STATE OF CONNECTICUT SITING COUNCIL

PETITION NO. 1398

PETITIONER LSE PICTOR LLC'S RESPONSES TO SITING COUNCIL INTERROGATORIES **DATED APRIL 21, 2020**

**SITE DEVELOPMENT PLANS
PROPOSED 1.99 MW SOLAR ARRAY
PLATT HILL ROAD
WINCHESTER, CONNECTICUT
PREPARED FOR LODESTAR ENERGY**

CONSTRUCTION NARRATIVE
SHEET 13 OF 13
PROJECT #032-2019
SCALE: 1" = 150'
DATE: 3/6/2020, Rev. 5/1/20

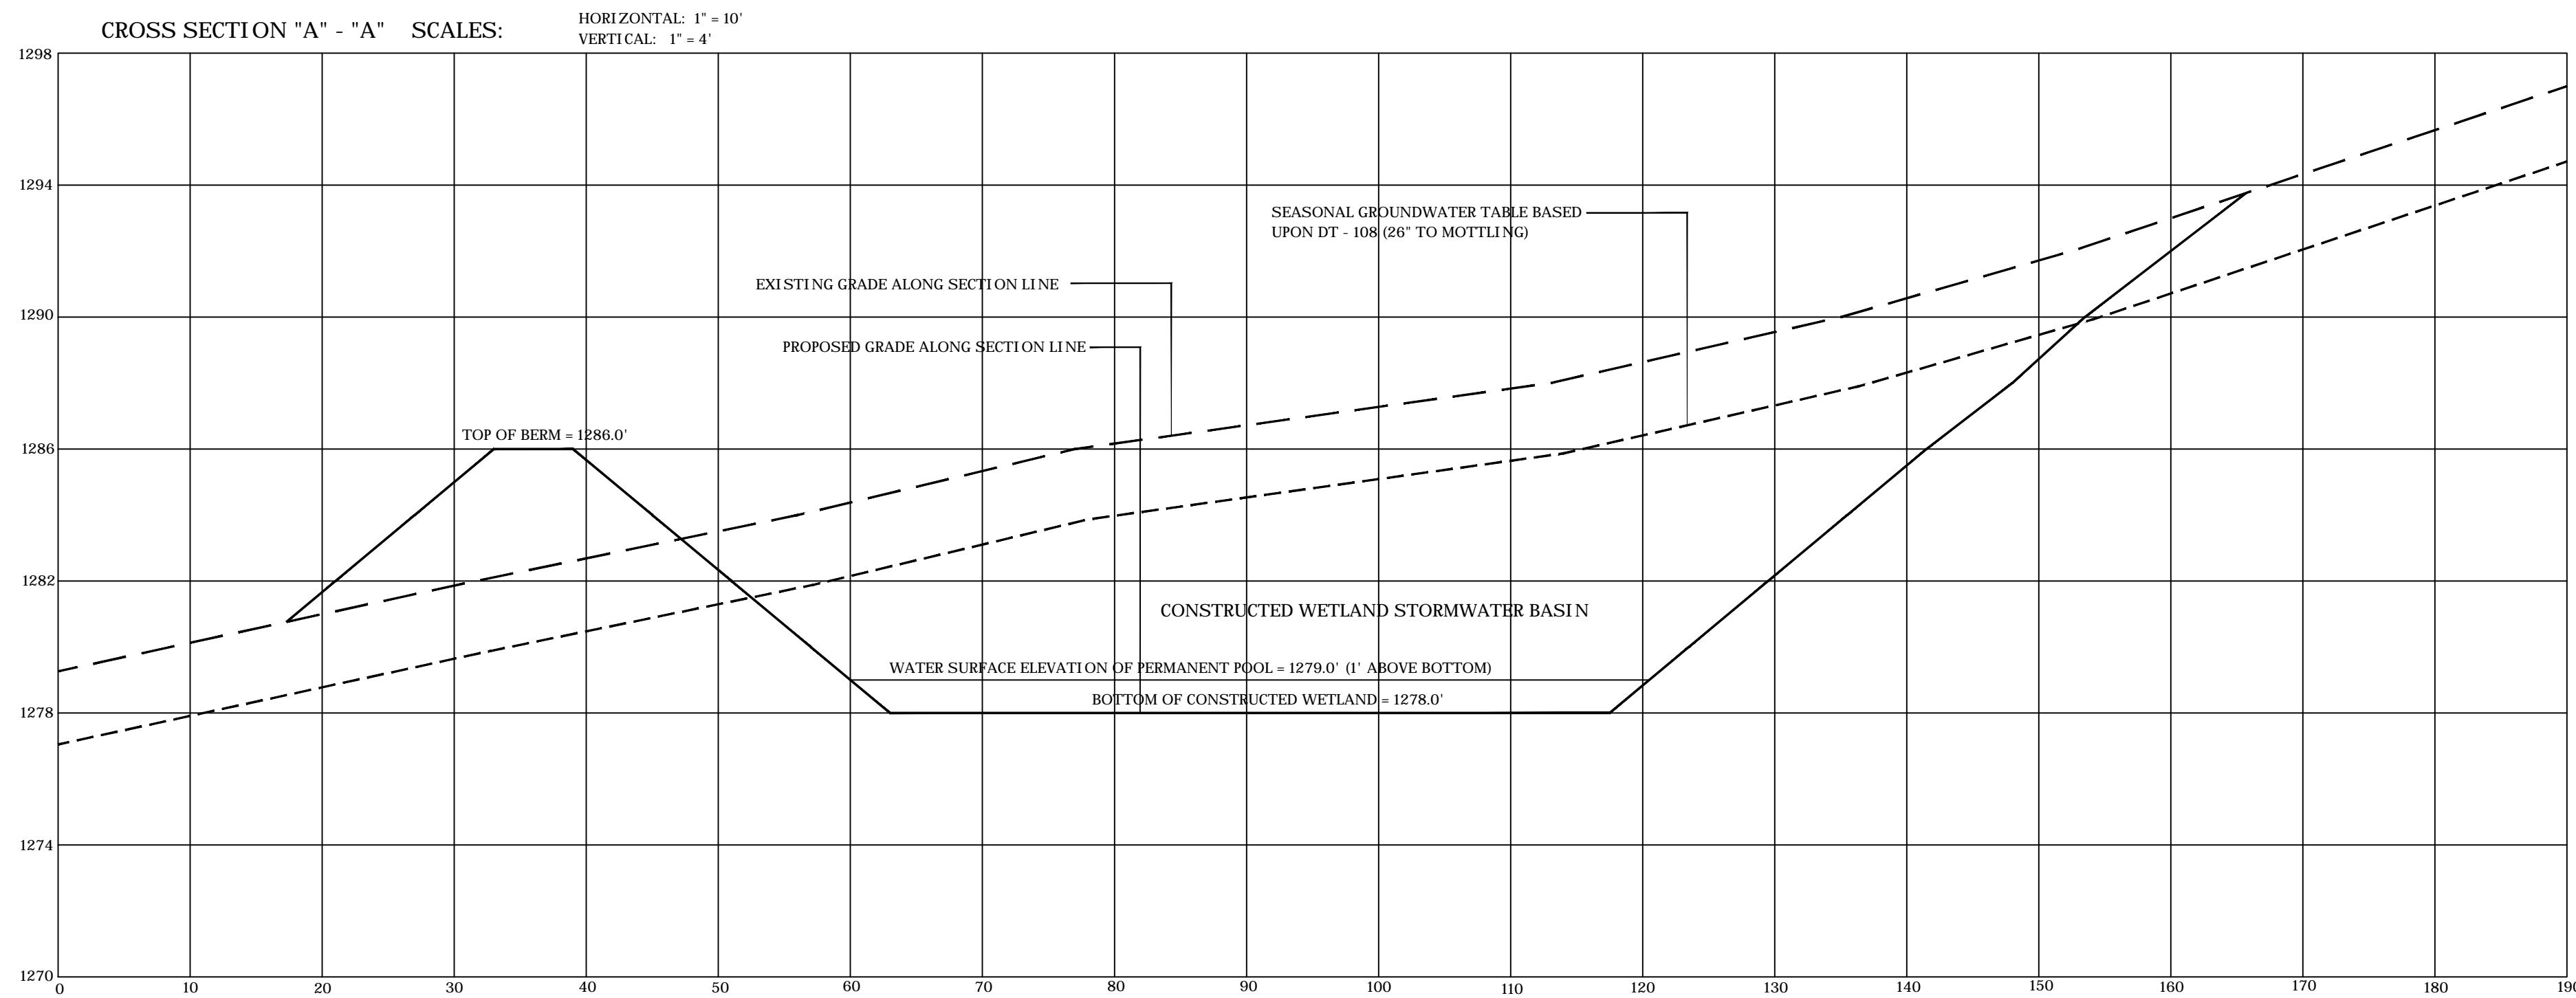
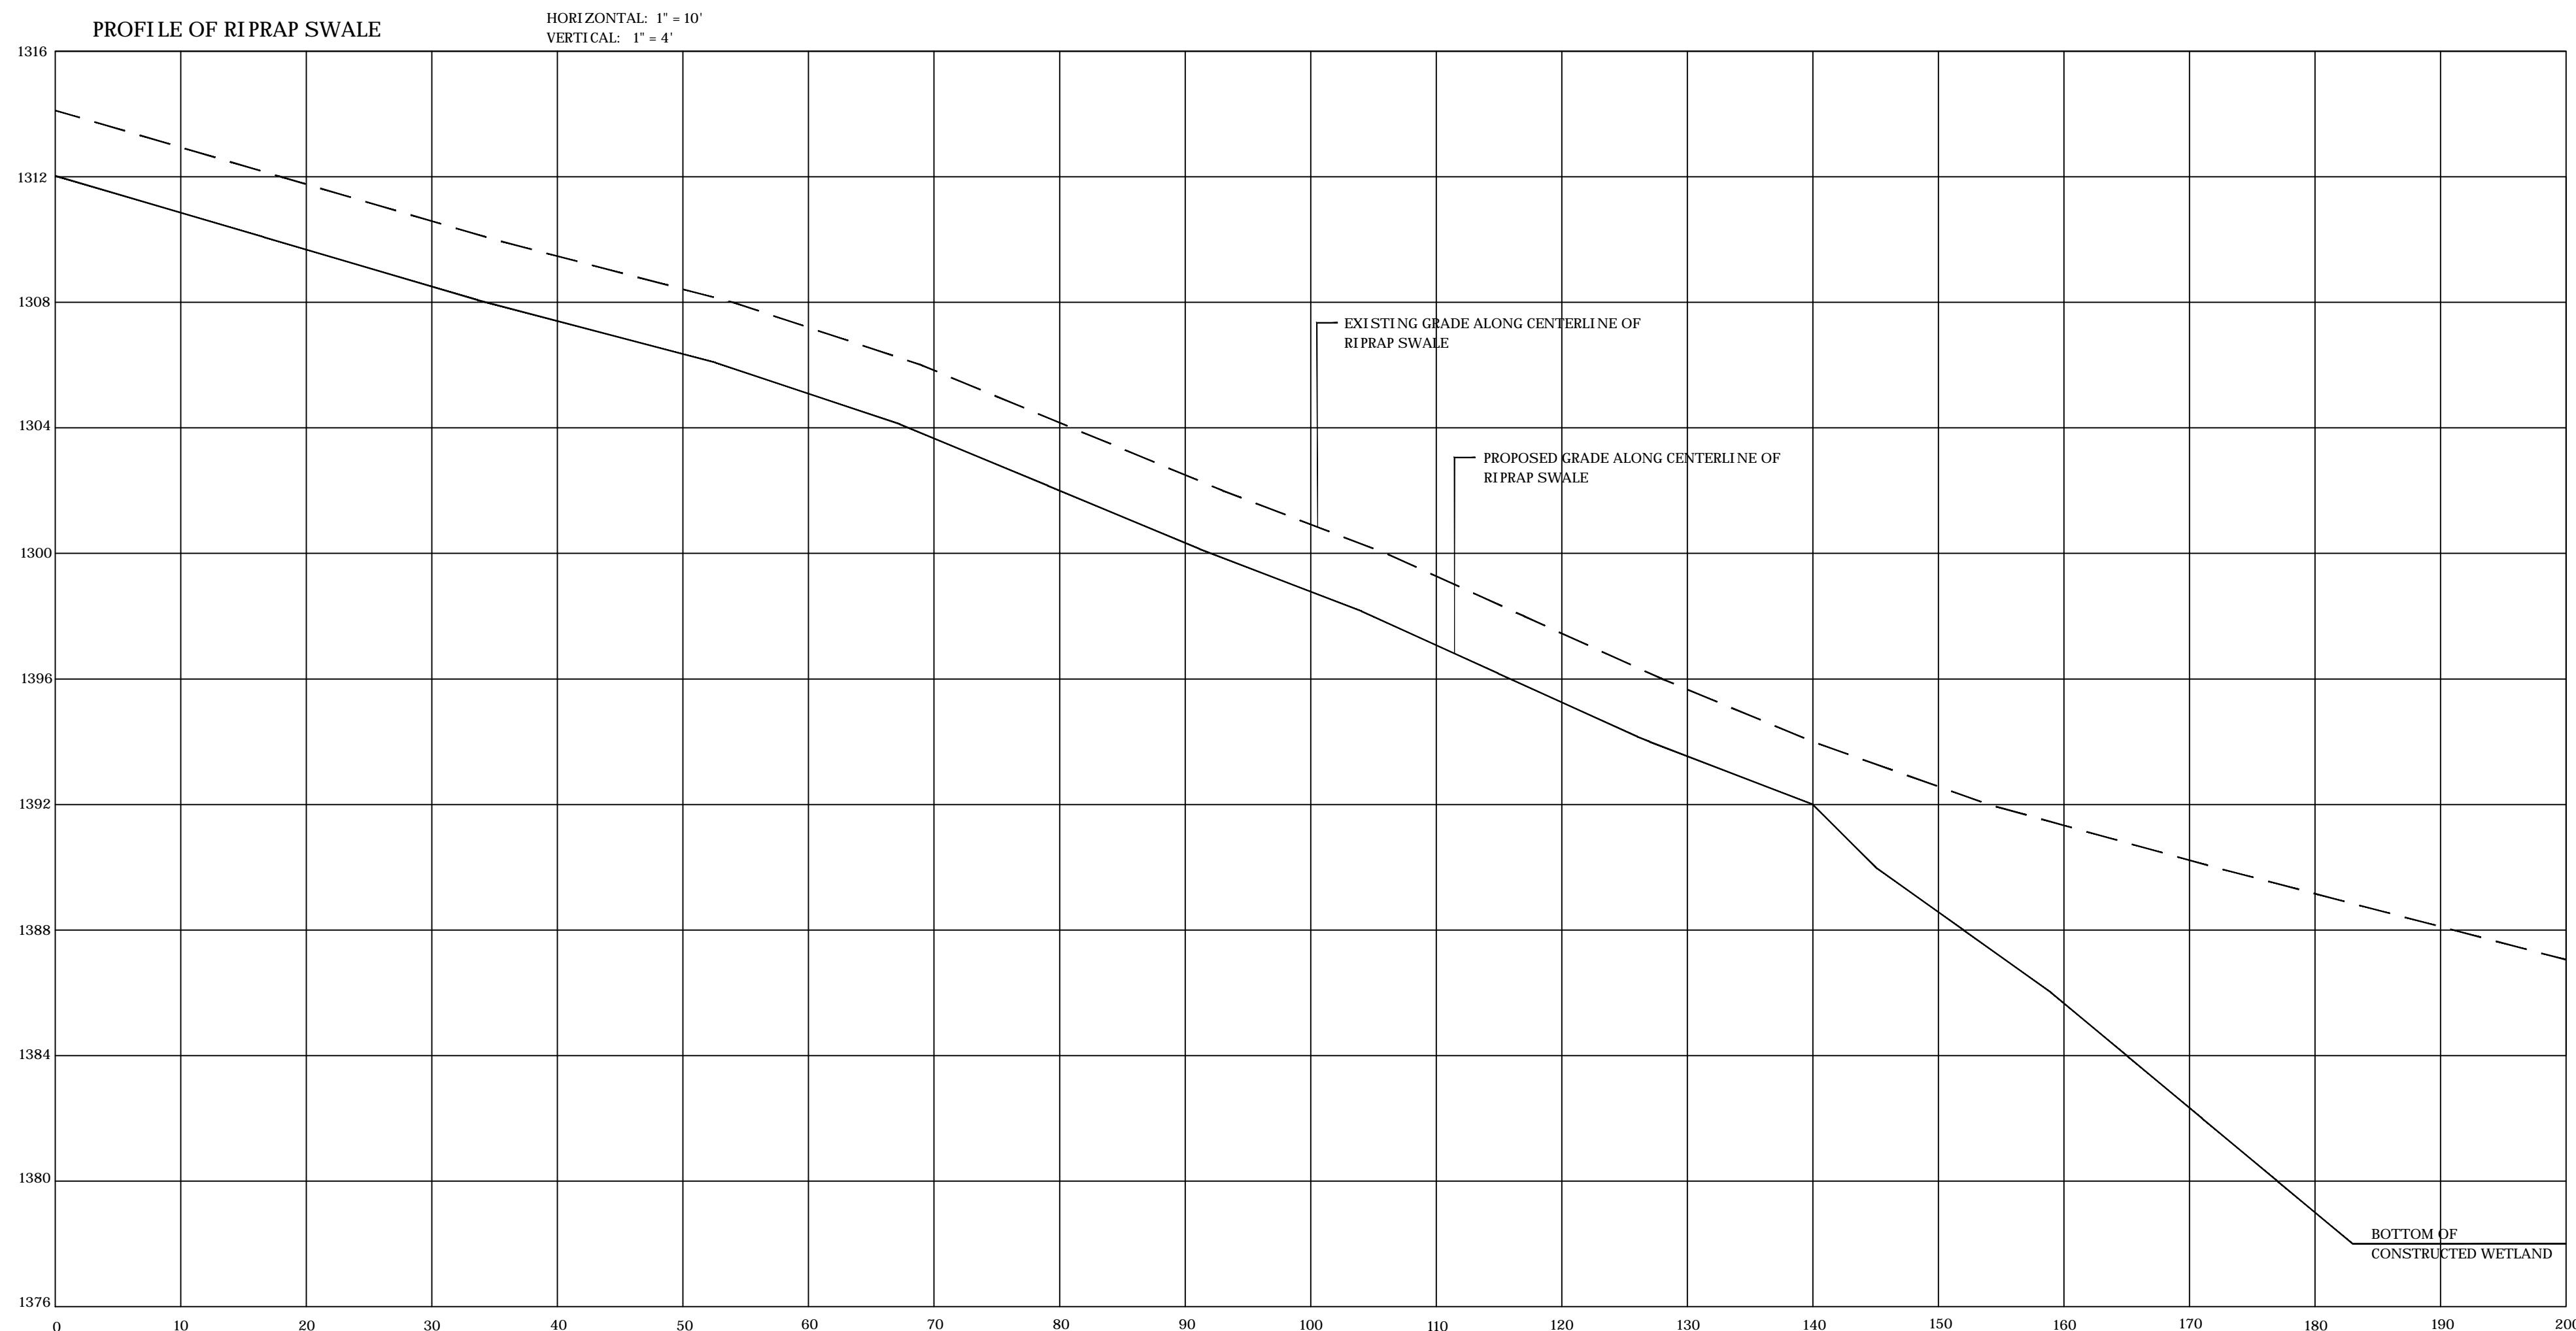
38. *Site plan 13- Notes, Please address the following:*

b) Section GENERAL EROSION AND SEDIMENTATION CONTROL PLAN NOTES – -- #7 where will accumulated sediment be disposed of? --#8, #9, & #10 - please clarify the information provided.

63. ***The Operations and Maintenance Plan does not contain specific post-construction inspection, maintenance, or corrective action protocols for the wetland detention pond and associated stormwater control swales. Please provide details consistent with the 2004 Connecticut Stormwater Quality Manual and the 2002 Connecticut Guidelines for Soil Erosion and Sediment Control.***

Please see revised plans attached hereto as Exhibit A. Filtrexx Soxx are a much more effective sedimentation barrier than a siltation fence so they only need to be inspected on a monthly basis. As Petitioner is not proposing to remove the topsoil or otherwise disturbing the soil in the area of the array, there will likely be little to no accumulation of sediment behind a control barrier. If any sediment does accumulate it will be removed and hand spread in an upland area outside the limit of the array area. The notes referenced are in conformance with CT DEEP 2002 Soil Erosion and Sediment Control Guidelines.

Maintenance requirements for the constructed wetland and grass swales have been added to the revised plans, attached hereto as Exhibit A. Both of these systems were chosen as they require minimal maintenance to function properly and such maintenance complies with the 2004 Stormwater Quality Manual and 2002 Soil Erosion and Sediment Control guidelines.
